3rd Party API RBI Consequence Model Review

API RBI User Group Meeting
Houston Marriott, Greenspoint

Philip A. Henry
March 21, 2007

- Two-Phase Releases

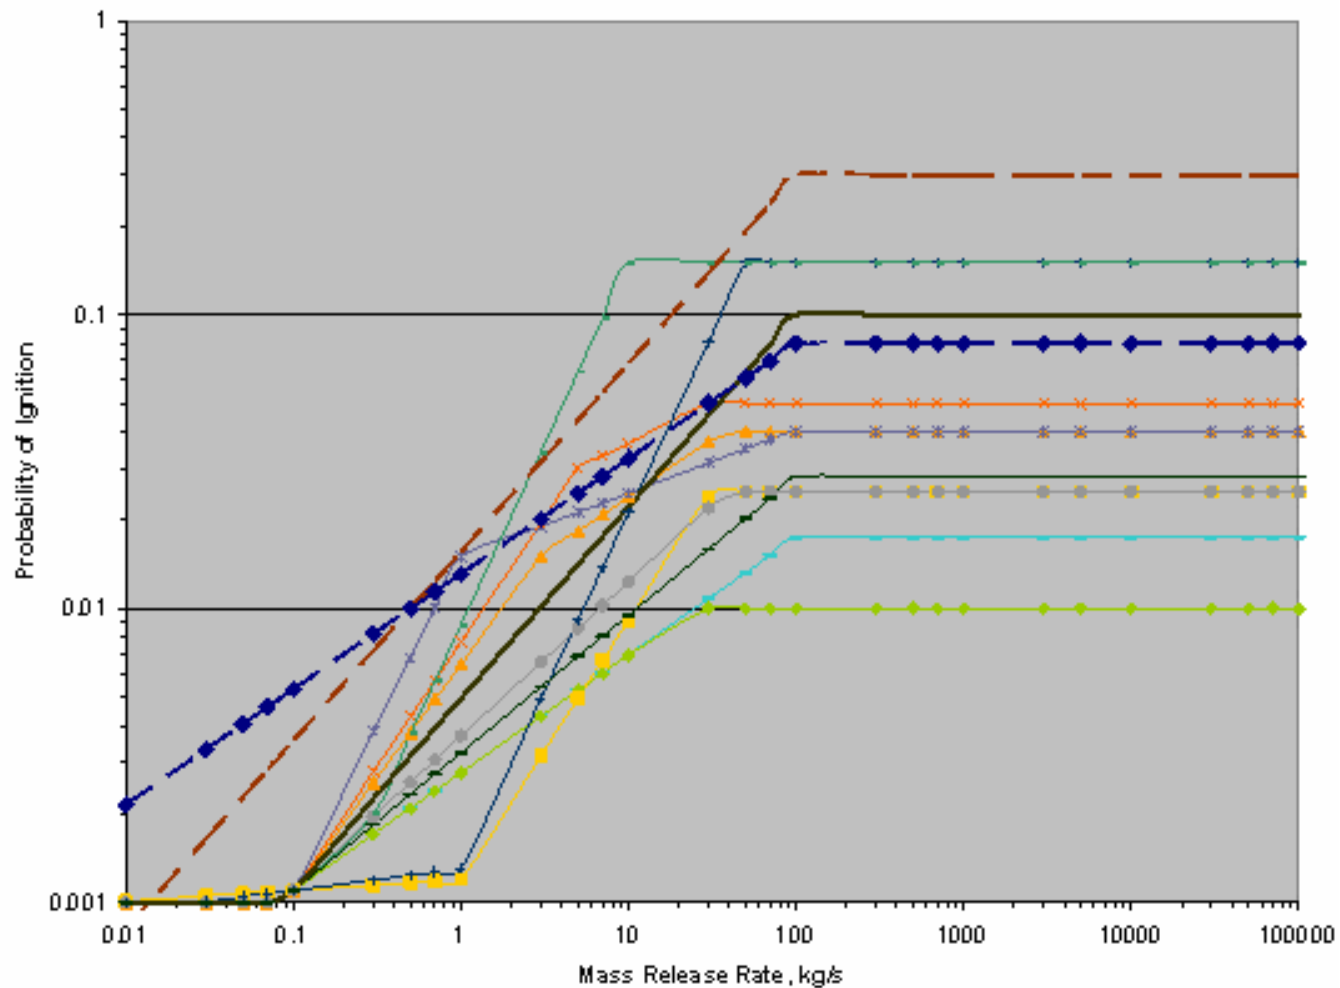
- LEVEL 2 COMMENTS
 - Additional text with one or two examples is needed to show how mixtures are treated
 - How do we model vapor and liquid releases, same composition or ideal mixture
 - Cloud coming off of pool, properties used
 - Two-phase releases should be modeled as two-phase releases only. No assumptions treating the release as a liquid only should be made. Potential inaccuracies are shown by the following figure for a chlorine release which contrasts the difference only a few degrees makes on the atmospheric source strengths (predicted by ALOHA 5.2) for two-phase flow and pool evaporation.

- LEVEL 2 COMMENTS (Con't)
 - Probabilities of ignition, MW curves versus flash point

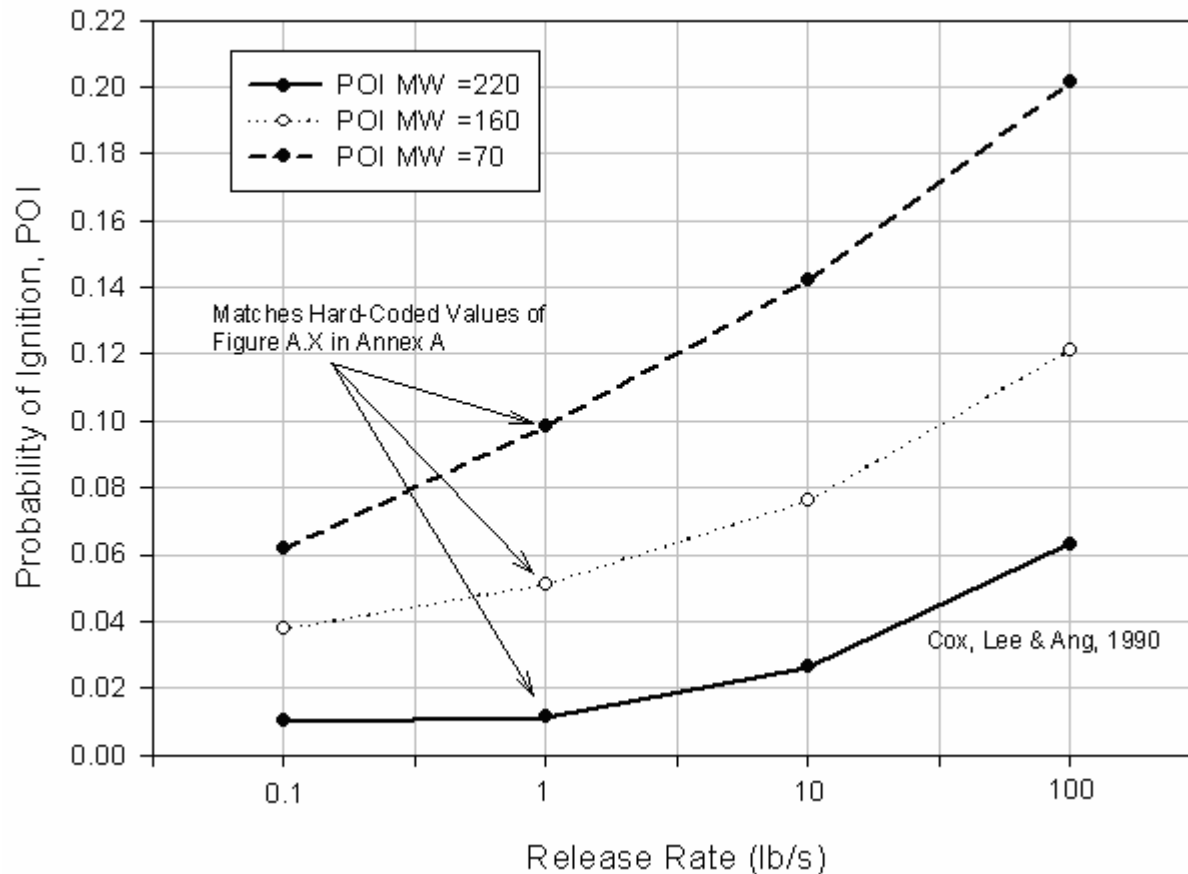
- LEVEL 2 COMMENTS (Con't)
 - The values for the probability of ignition employed in the event trees are a significant improvement over Level 1 and are consistent with current research. For example, the Energy Institute in the United Kingdom has performed extensive research on ignition probabilities and has published a number of reports on this topic. One report, *Ignition Probability Review, Model Development and Look-up Correlations*, 1st ed., Jan 2006, ISBN 978 0 85293 454 8, relates ignition probability to the mass release rate.
 - These data could be analyzed to produce more robust correlations than those shown by Cox, Lee, and Ang (1990) in Figures 6.4 through 6.7.
 - The following figure shows how curves from their research are similar to the work of Cox, Lee, and Ang cited in Section 6.8.1.2.
